Abatement coefficient g in RCC-MRx RB3650 (for high-temperature type-P nuclear piping analysis)

Irénée Cornaton[1], Chau-Thuy Pham[1], and 'To be defined'[2]

Figure 1: A typical piping structure modelled under PEPS 8.0 (modified based on client model)

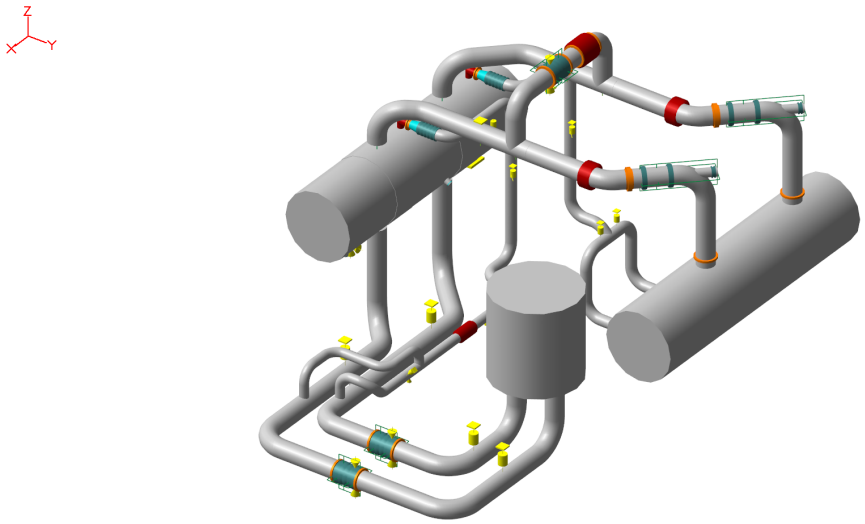
For the above figure: add some equipments, remove all small piping portions ; add all components mentionned in the first paragraph in this structure

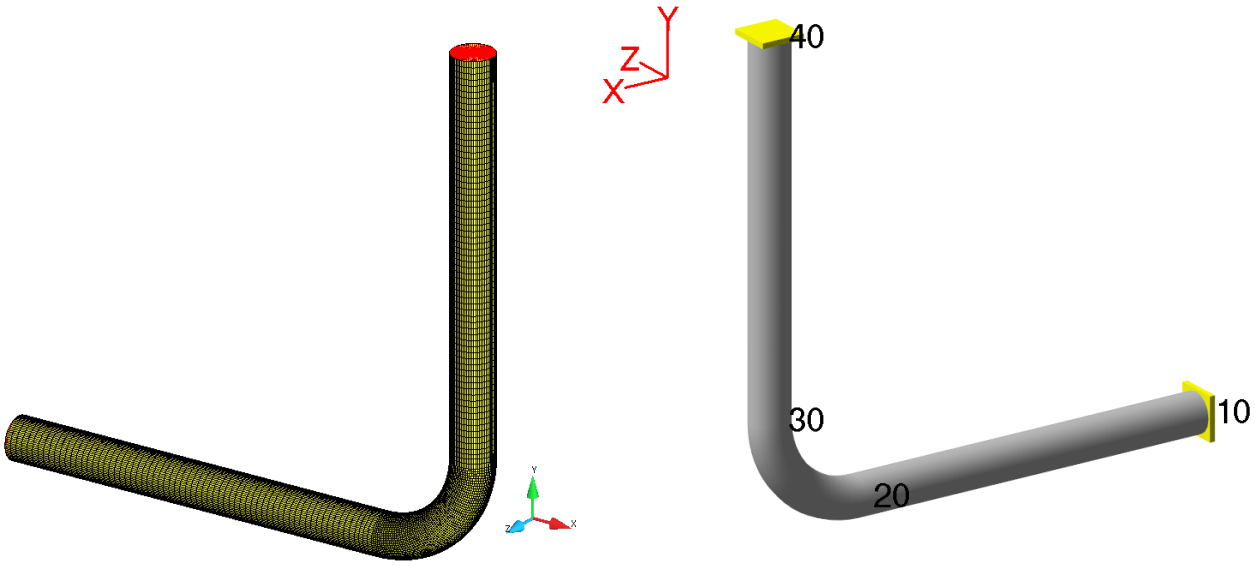
Present the impact of pressure on the ovalization here + introduce the pressure ovalization correction

Note: it might be impossible to consider pressure in this work. Because Marc will have to explicitly consider pressure load, but here we only want the pressure effects on the elbows' flexibility (deformation) and consider only thermal exp −> to discuss more

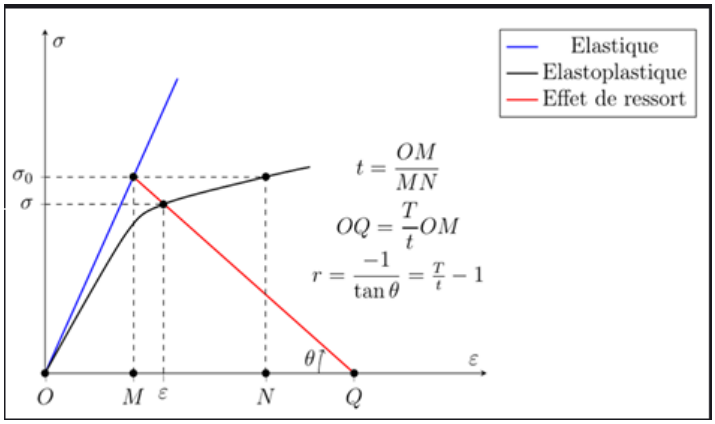
Figure 10: Graphical construction of r_M, reproduced directly from the presentation: $\sigma_0 = \sigma_{\text{el}}$ is the elastic reference stress at point M, σ the actual elasto-plastic stress reached at the same strain ε; the local resilience is $t = OM/MN$, the global resilience T is such that $OQ = (T/t)\,OM$, and the spring-effect line of slope $-1/r_M = \tan\theta$ passes through M and Q.–> to be replaced by a latex code + make it similar to Figure 2

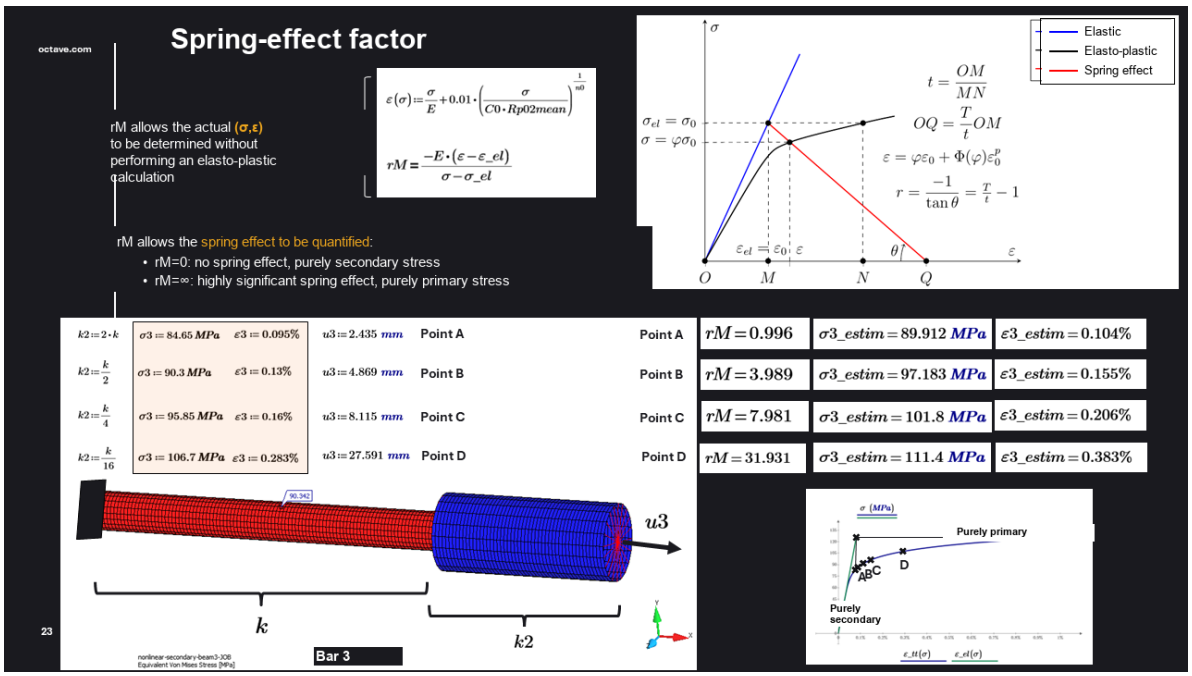
Figure 11: Parametric three-bar sweep extracted from the presentation: reducing the added spring stiffness from $k_2 = 2k$ to $k_2 = k/16$ drives Bar 3 continuously away from the purely secondary limit (Bar 2) and towards the primary-like limit (Bar 1). The slide reports the corresponding sequence of follow-up factors ($r_M = 0.996$, 3.989, 7.981, 31.931), stress estimates ($\sigma_{3,\mathrm{est}} = 89.912\,\mathrm{MPa}$, $97.183\,\mathrm{MPa}$, $101.8\,\mathrm{MPa}$ and $111.4\,\mathrm{MPa}$) and end displacements ($u_3 = 2.435\,\mathrm{mm}$, $4.869\,\mathrm{mm}$, $8.115\,\mathrm{mm}$ and $27.591\,\mathrm{mm}$).–> to redesign. Don't let the rM curve occur too many times

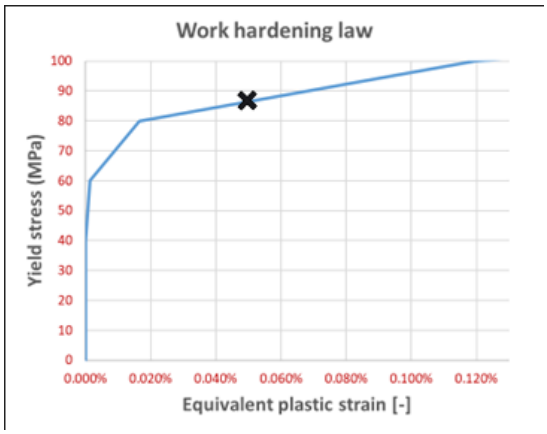
Figure 14: Zoom of the work-hardening law over the small-strain range relevant to the benchmark, with the retained critical-section point ($\sigma_{\mathrm{VM}} = 86.5\,\mathrm{MPa}$, $\varepsilon_{p,\mathrm{eq}} = 0.05\,\%$) marked, confirming its consistency with the imposed FE hardening curve. –> figure to remove

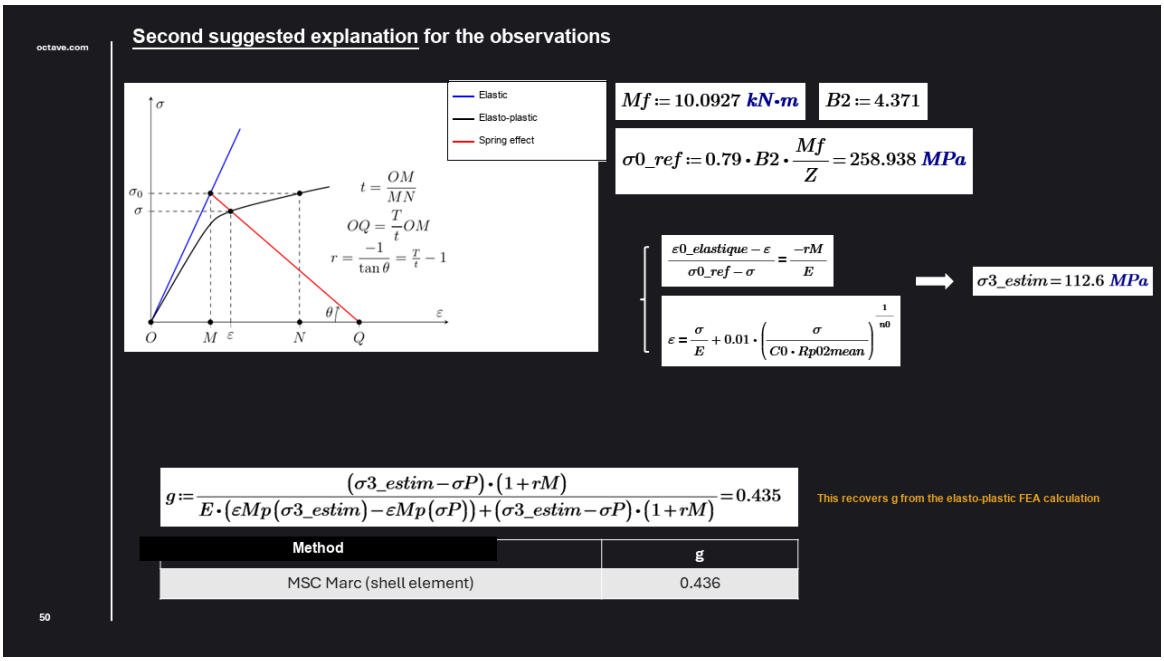
Figure 18: Second FE-side consistency check reproduced from the presentation: starting from the shell-model reaction moment $M_f = 10.0927\,\text{kN m}$ and the piping-code coefficient $B_2 = 4.371$, the equivalent elastic reference stress is reconstructed as $\sigma_{0,\text{ref}} = 0.79\,B_2\,M_f/Z = 258.938\,\text{MPa}$. Solving the coupled elastic-follow-up and Ramberg–Osgood relations shown on the slide then gives $\sigma_{3,\text{est}} = 112.6\,\text{MPa}$ and $g = 0.435$, i.e. the reaction-based FE abatement coefficient $g_{\text{reaction}} = 0.436$ to within rounding. –> to redesign

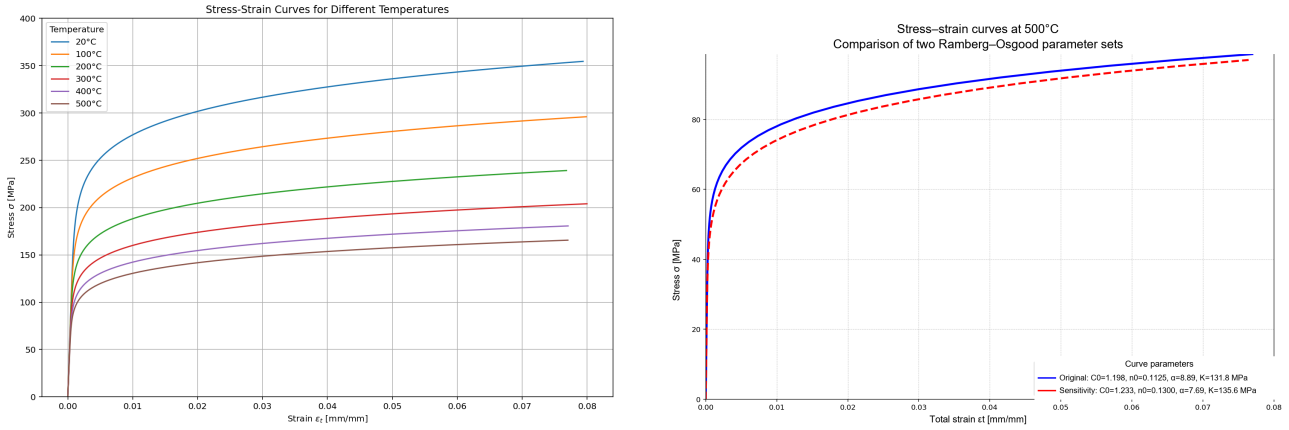
Figure 19: Ramberg–Osgood material data extracted from the presentation. Left: family of 316L(N) stress–strain curves used to justify the temperature-dependent scaling of the law through $R_{p0.2}(T)$. Right: sensitivity check at 500 °C (a different temperature from the 550 °C benchmark), comparing the reference parameter set ($C_0 = 1.198$, $n_0 = 0.1125$, $C_0 R_{p0.2} \approx 131.8$ MPa) with the alternative fit ($C_0 = 1.233$, $n_0 = 0.130$, $C_0 R_{p0.2} \approx 135.6$ MPa) discussed in the text. –>show the importance of n0/C0 on the final results
